► MEMORANDUM

To: Elizabeth Wong, PE (City of North Port)
From: Dave DeLoach, PE; Trillian Baldassari, PE
Copy: Rod Ghioto, PE
File: 14-00400-00

Subject: Task 1.4 Big Slough Flood Reduction Study, Potential Solutions for Hydraulic Evaluation

January 30, 2017

Parallel Relief Channel (as Conceived by CDM, 1993)

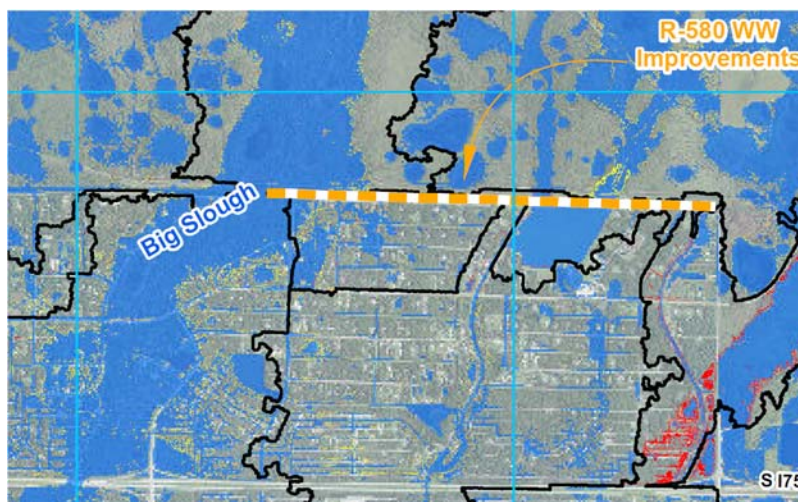
Meeting comments: Staff indicated that this project would need to show promise with properties acquired to date or with additional properties which could reasonably be expected to be acquired by means other than eminent domain.

Diversion to Deer Prairie Slough, Pumped with Storage on Futrell Tract (as Conceived by CDM, 1993)

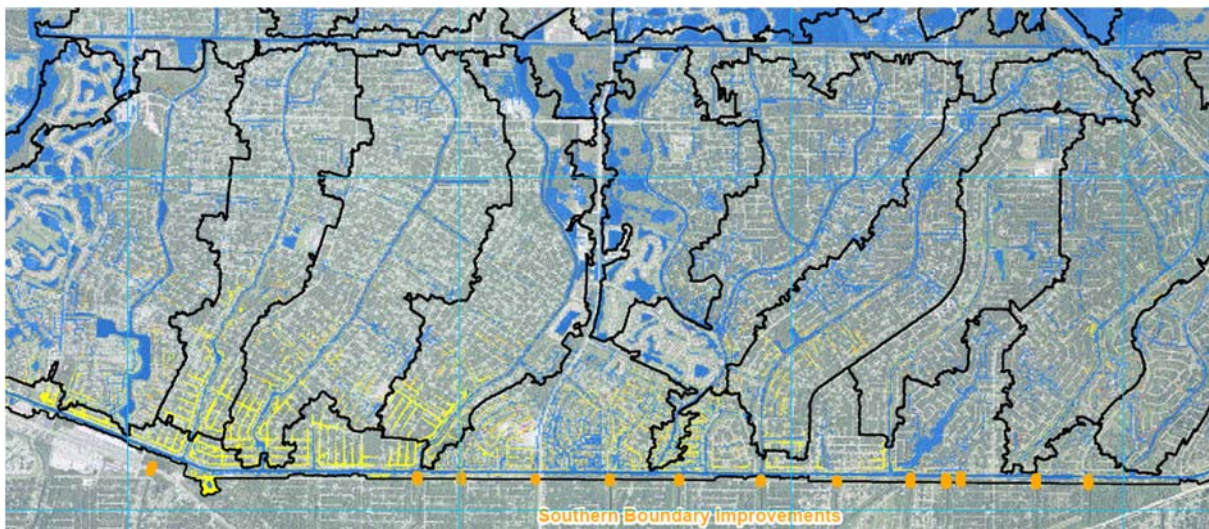
Meeting comments: Staff inquired whether it is possible to determine how much stormwater historically moved into Deer Prairie Slough from the Big Slough and City of North Port systems prior to construction of canals by GDC. DES staff indicated that a rough calculation could be made but that it wouldn't have much of an effect on decision making. Rather, we should gather and review available information on the Deer Prairie Slough restoration project and coordinate with District staff on potential offsite inflow restoration. City staff requested that the District share any reports that are available and identify individuals to contact for a January follow-up meeting. DES staff inquired as to the status of the Futrell tract and City staff indicated that the District did not look favorably on using the tract for a reservoir. Additional District staff could be invited to attend the follow-up meeting to discuss alternate uses of the Futrell tract that might be of mutual benefit.

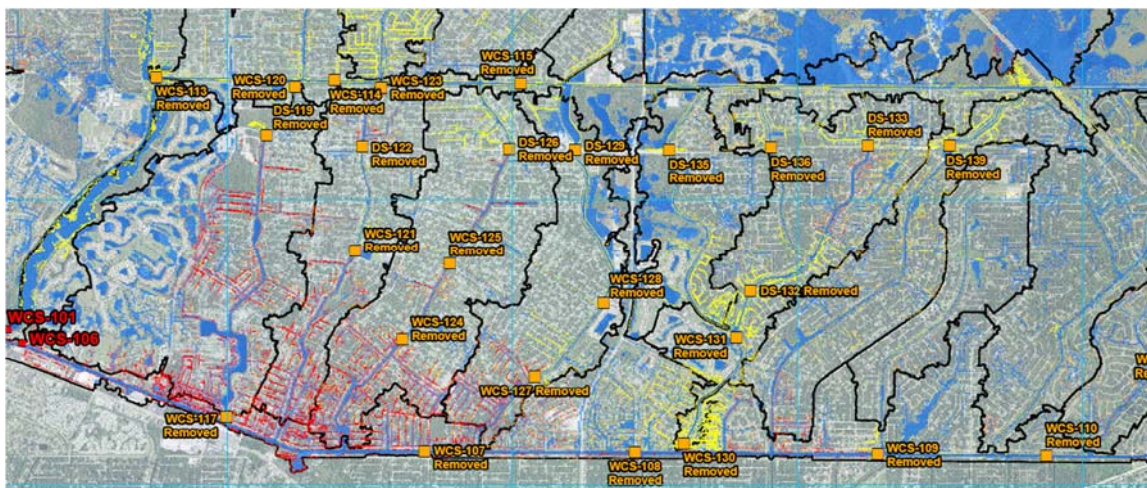
Meeting comments: Team agree to include this concept in the master plan, understanding that it also encompasses improvements to existing culverts at Tropicaire and I-75. During prior analysis, some coordination was held with FDOT and concept was shelved because of downstream impacts which were beyond the scope of that earlier analysis. Window of opportunity may have closed with FDOT on near-term improvements at I-75. One concern is whether the downstream infrastructure can handle the increased flow without substantial modification. Staff pointed out that the WCS-101 structure is tidally influenced and suggested evaluation should consider worst case tidal conditions.

Diversion of Flows Southward, by System-wide Structure Removal (as Conceived by Ardaman, 2014)

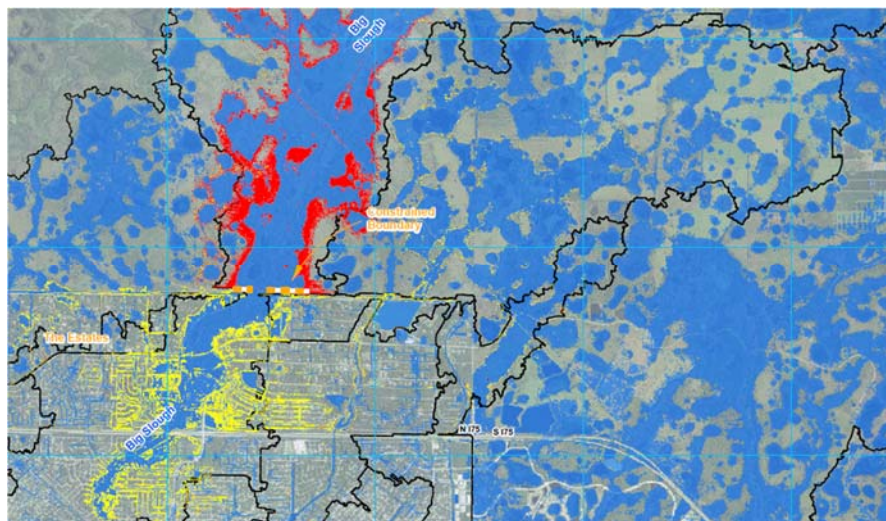
Meeting comments: Staff indicated that there may be an opportunity to store more water in the existing canal system for smaller events by raising gates. DES pointed out that the Panacea community discharges to some of those canals and that raising levels may have adverse impacts on those upstream stormwater management systems.

Constrained Inflows and Increased US Floodplain Storage (as Conceived by Ardaman, 2014)

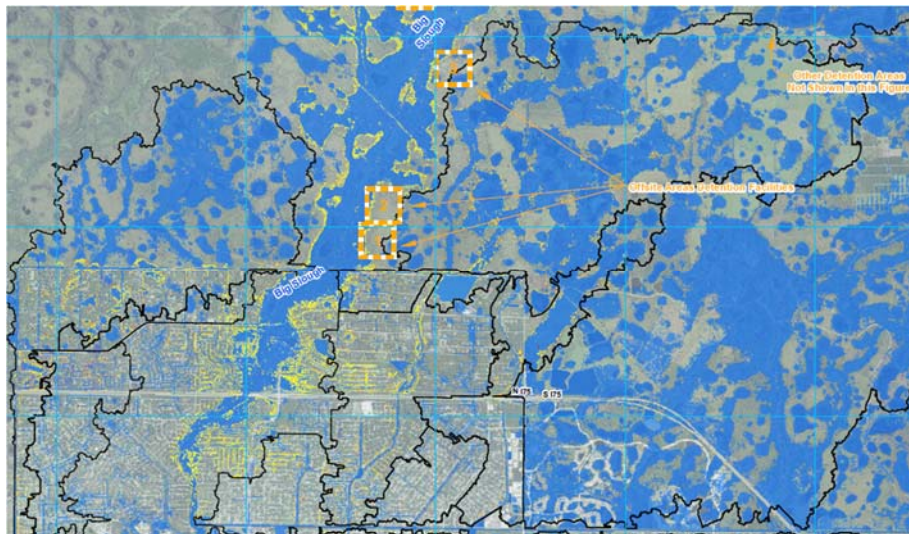
Meeting comments: The team agreed that prior work focused mainly on larger storm events and that this project may be able to achieve benefits for smaller storms with upstream impacts that might be successfully mitigated.

Upstream Detention Storage (as Conceived by Ardaman, 2014)

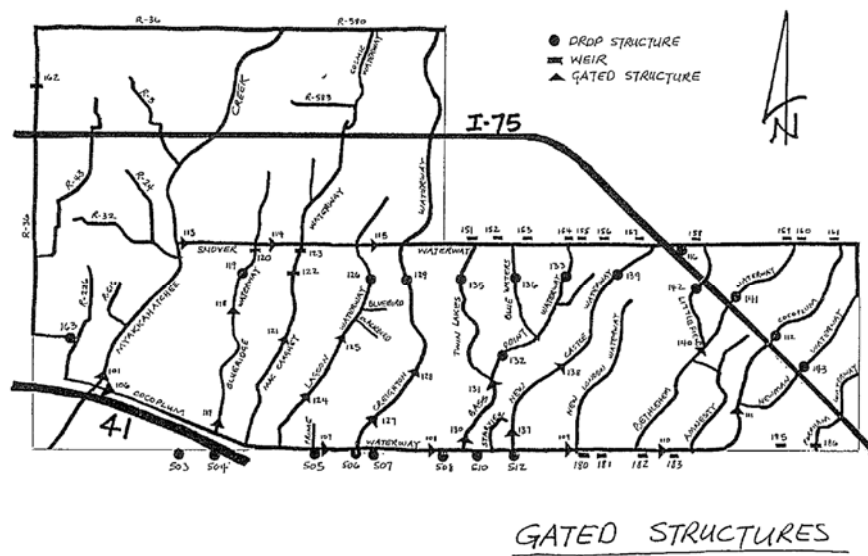
Meeting comments: Staff indicated that the City Manager recently toured (and is interested in developing facilities similar to) the Celery Fields in Sarasota County and inquired as to whether additional District funding might be available in the project combined flood reduction and water quality benefits. Staff also pointed out that operating and maintaining multiple offsite reservoirs (six were considered in the prior evaluation) would be challenging.
